# Functional Differences Between Masks 0H82G and 4J22A of the DSP56303

This document describes the differences between two masks of the DSP56303: the newer mask 0H82G and mask immediately preceding it 4J22A.

**Figure 1.** Operating Mode Register (OMR)

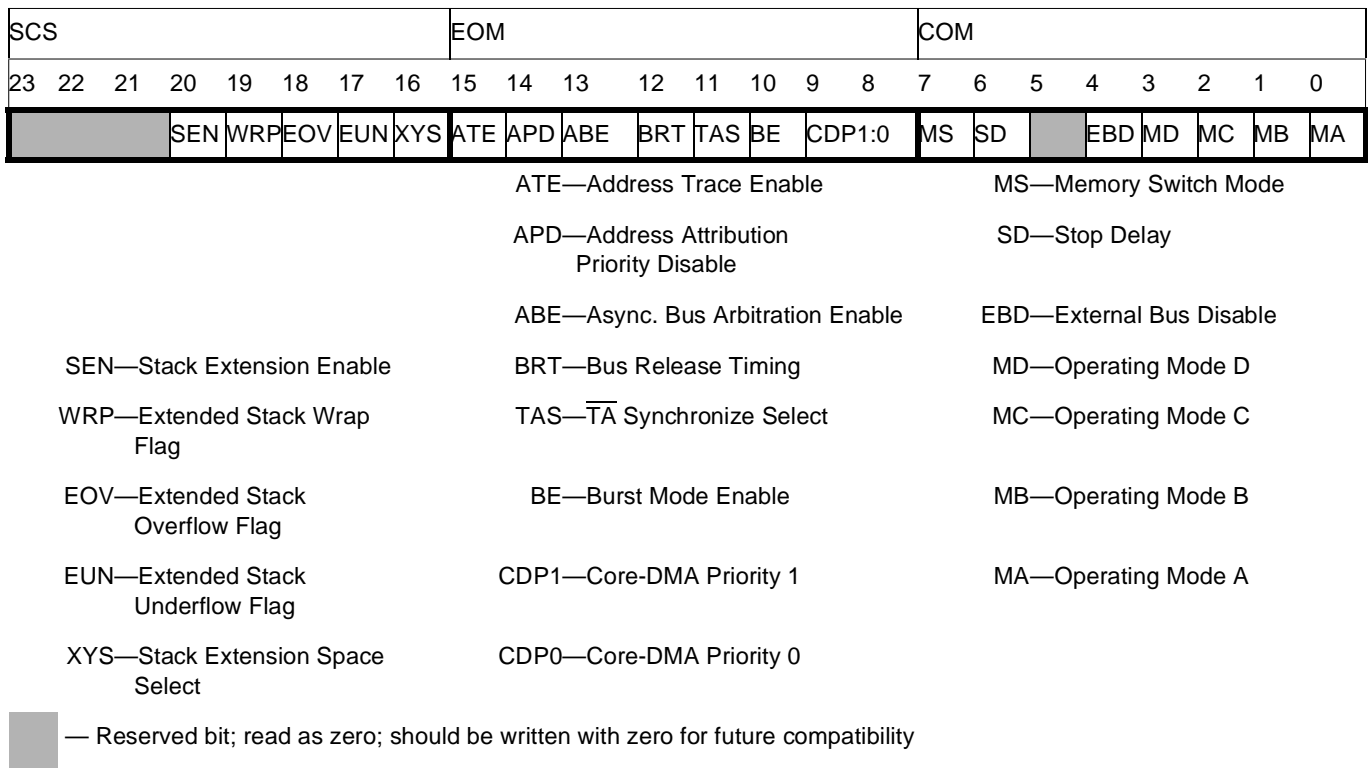
In the Operating Mode Register (OMR) of the 0H82G is a new Asynchronous Bus Arbitration (ABE) bit to support external access at high frequencies. As **Figure 1** shows, bit 13 in the OMR enables Asynchronous Bus Arbitration. For convenience, **Table 2** defines all the OMR bits available in the 0H82G mask set of the DSP56303. The new ABE bit is highlighted in a bold red font.

Bit Number	Bit Name	Reset Value	Description	
13	ABE	0	<p><b>Asynchronous Bus Arbitration Enable</b> Eliminates the setup and hold time requirements (with respect to CLKOUT) for <math>\overline{BB}</math> and <math>\overline{BG}</math>, and substitutes a required non-overlap interval between the deassertion of one BG input to a DSP56300 family device and the assertion of a second BG input to a second DSP56300 family device on the same bus. When the ABE bit is set, the <math>\overline{BG}</math> and <math>\overline{BB}</math> inputs are synchronized. This synchronization causes a delay between a change in <math>\overline{BG}</math> or <math>\overline{BB}</math> until this change is actually accepted by the receiving device.</p>	
12	BRT	0	<p><b>Bus Release Timing</b> Selects between fast or slow bus release. If BRT is cleared, a Fast Bus Release mode is selected (that is, no additional cycles are added to the access and BB is not guaranteed to be the last Port A pin that is tri-stated at the end of the access). If BRT is set, a Slow Bus Release mode is selected (that is, an additional cycle is added to the access, and BB is the last Port A pin that is tri-stated at the end of the access).</p>
